Three Mile Island Nuclear Station
Special Operating Procedure

SOP No. E-61
(From SOP Log Index)

1. Title JOG CONTROL FOR RC-UZ

*Provide guidance for wiring modifications for jog control
of RC-UE. (To allow use as alternate design method for Prohibit)*

Dwg 3075 Sh 52

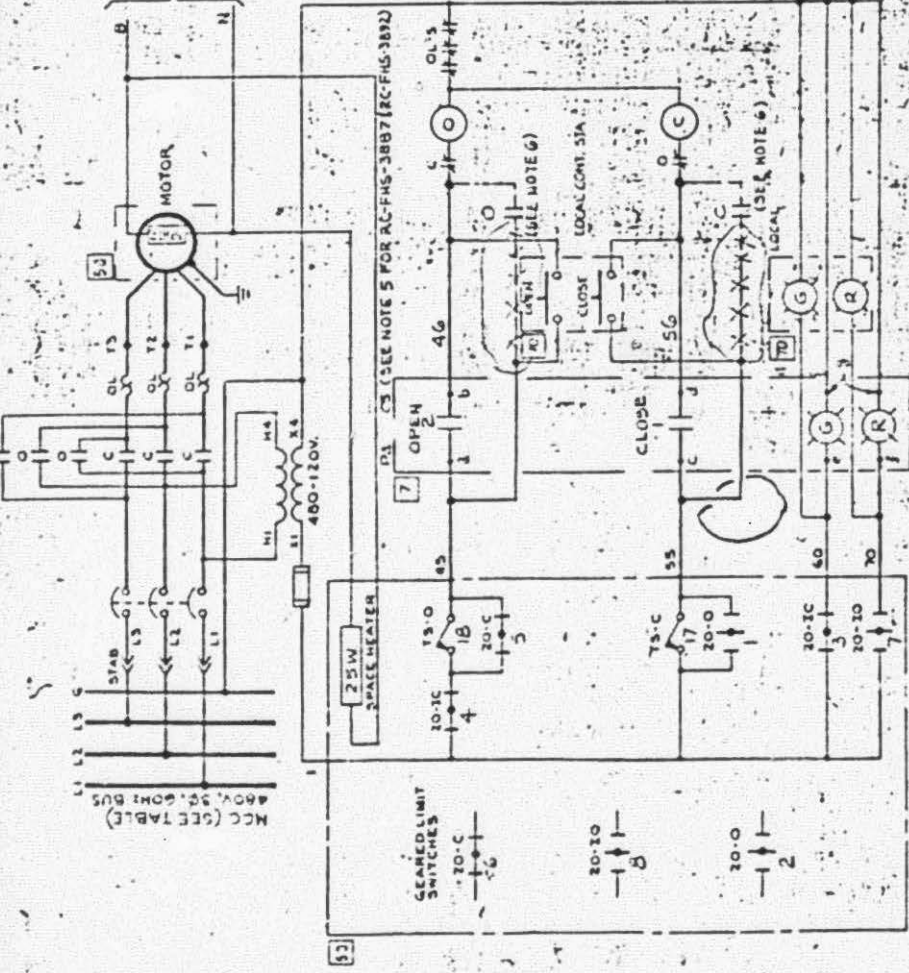
1. Ensure electrician reviews attached drawings prior to commencing work. (Draw 3025 Sh 52 & Draw 3033 Sh 84R - both attached)
2. Obtain RWP

1. Notify Shift Foreman/Supervisor prior to commencing work. Minimize entry time and working time
2. Ensure RC-VZ is closed prior to tripping MCC breaker.
3. Trip breaker @ MCC 2-32B Compartment 4BR.
4. Locate and lift ~~lead~~ internal lead between terminal 45 and N.O. contact of "O" starter.
5. Locate and lift internal lead between terminal 55 and N.O. contact of "C" starter.
6. During a previous attempt to provide jog control for RC-VZ, the internal jumpers between Term 45 to A45 and between 55 to A55 ^{may have been} removed. Reconnect jumpers if time permits (This will allow control of RC-VZ from local control station)
7. Close breaker @ MCC 2-32B Compartment 4BR
8. Notify Shift Foreman/Supervisor after work is completed.
9. Enter lifted leads in jumper and lifted lead log.

M. DIAG. 3075 (SHT. 52)

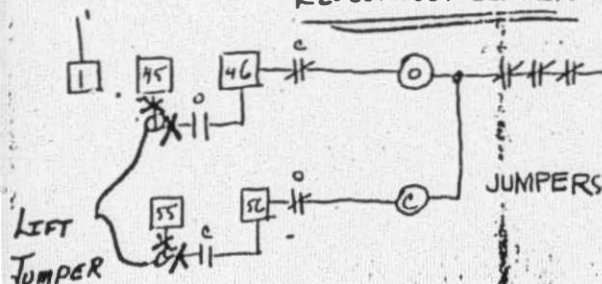
~~SAME AS UNIT IDR~~

~~(SEE DWG. 3033 RIR)~~

RE-Connect JUMPERS
